Title: Retrofit of an additional heat protection for the lower ignition cables for 915iS		
AG-SB-2024-2-B-EN	Effective Date: 01.03.2024 <b>WITHDRAWN 03.07.2025</b>	Compliance Category: <del>A – MANDATORY</del> <del>B – RECOMMENDED</del> <del>C – OPTIONAL</del>
Applicability		
Aircraft type & model:  Cavalon	Affected Serial number(s):  All fitted with Rotax 915iS engines up to serial V00564	
The maintenance manual to be referenced is this stated or subsequent issue.		As per AutoGyro website
This form is the response from AutoGyro GmbH either against a problem found in the product in service requiring a containment or rectification action, or as service information for aircraft modification incorporation. For help, contact <a href="mailto:airworthiness@auto-gyro.com">airworthiness@auto-gyro.com</a> .

**Reason and overview of the Service Bulletin (cause of problem if known)****03.07.2025: THIS SB IS WITHDRAWN WITH IMMEDIATE EFFECT**

Following market feedback, AutoGyro has improved the Rotax heat protection for the lower spark plug leads for Cavalon 915iS engines by the fitment of additional heat protection sleeves.

### Illustrations

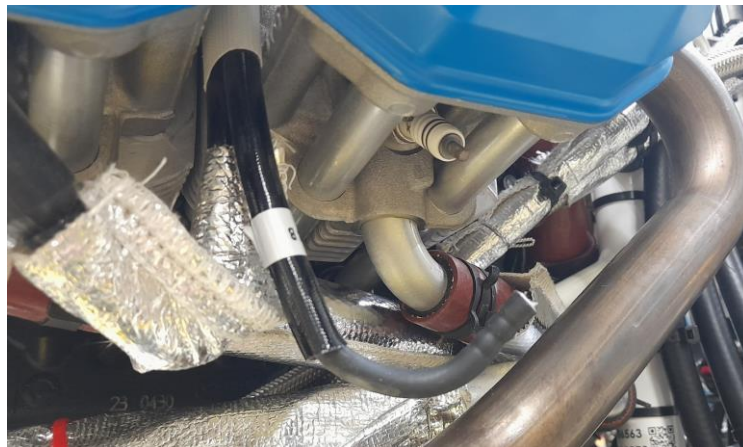
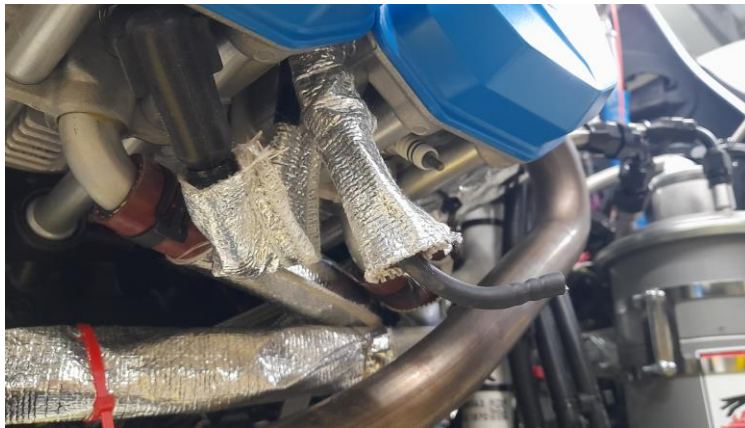
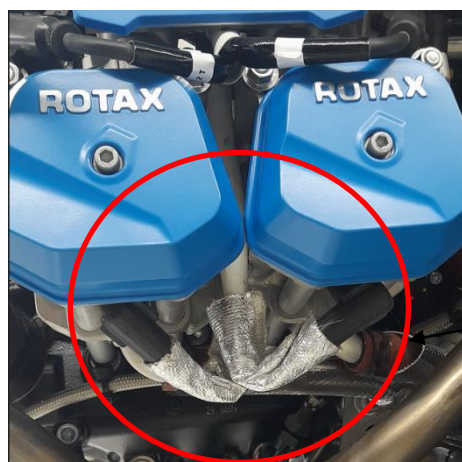
Old version with only Rotax heat protection:

Cable tie and spark plug connector removed:

Installed additional heat sleeve:

Spark plug connector screwed back on and new cable tie installed:

New version with Rotax and AutoGyro heat protection:

Additional AutoGyro heat protection

- 1.) Remove the cowling according to chapter 52-00-00 4-1.
- 2.) Remove the lower spark plug connectors from the spark plugs, noting which plug lead number connects to which plug, and remove the cable ties
- 3.) Unscrew the lower spark connector plugs from the ignition cables
- 4.) Add the additional heat protection
- 5.) Screw the spark plug connectors securely back onto the cables
